Environmental Assessment Comment Summary and Response for Enbridge Alberta Clipper Related Projects

June 18, 2009

Introduction

Figure 3.2.1-1
Alberta Clipper and Southern Lights Diluent Projects
 Typical Right-of-Way Configuration In Wetlands
 South of Existing Lines (Wisconsin Only)

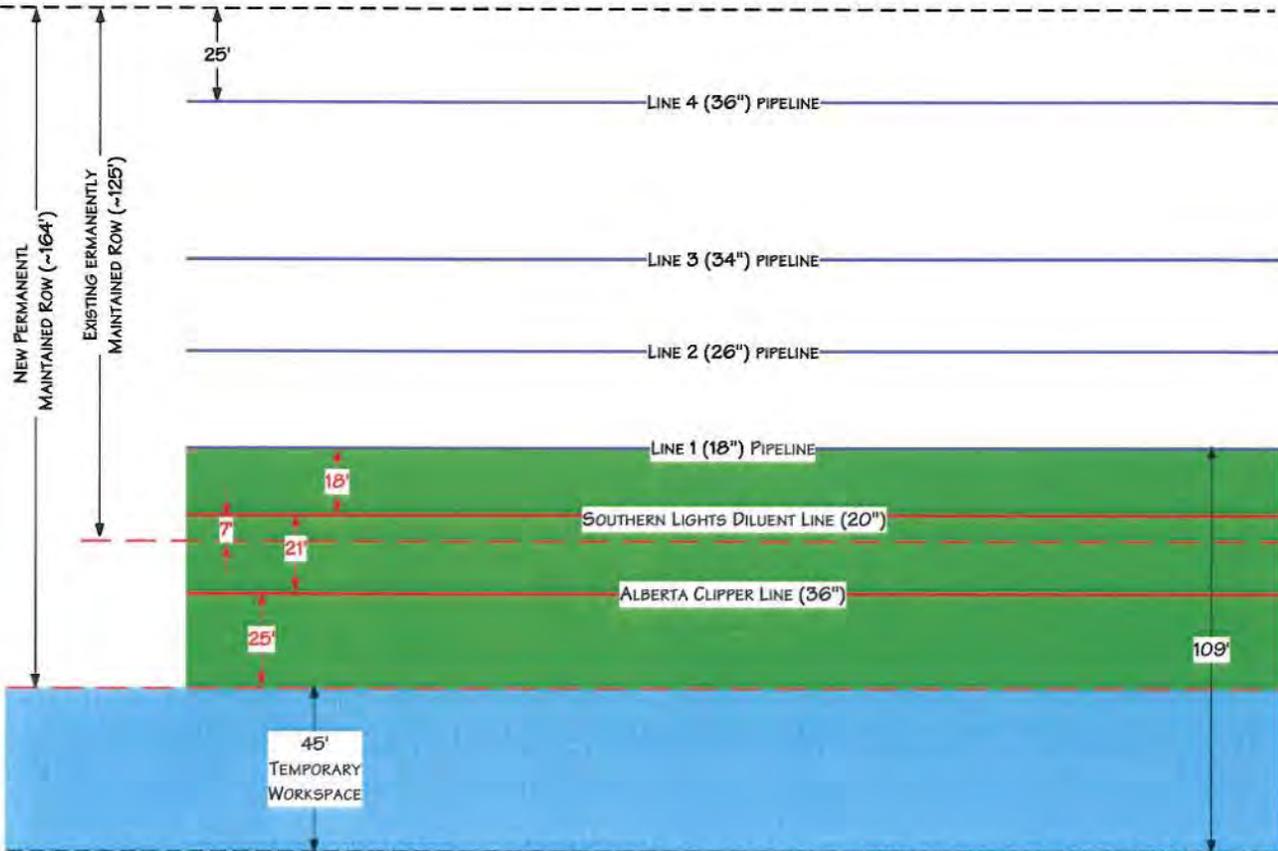
Comment: Section III.B.1, pages 53 and 54, Figures 7a & 7b: These figures reflect the workspace configuration proposed in the initial application. As discussed in the text, Enbridge reduced the spacing between the proposed pipelines based on the recommendations of a professional geotechnical engineer. Updated figures are attached as Exhibit 1.

Response: Comment noted. The EA is hereby amended as recommended in the comment.
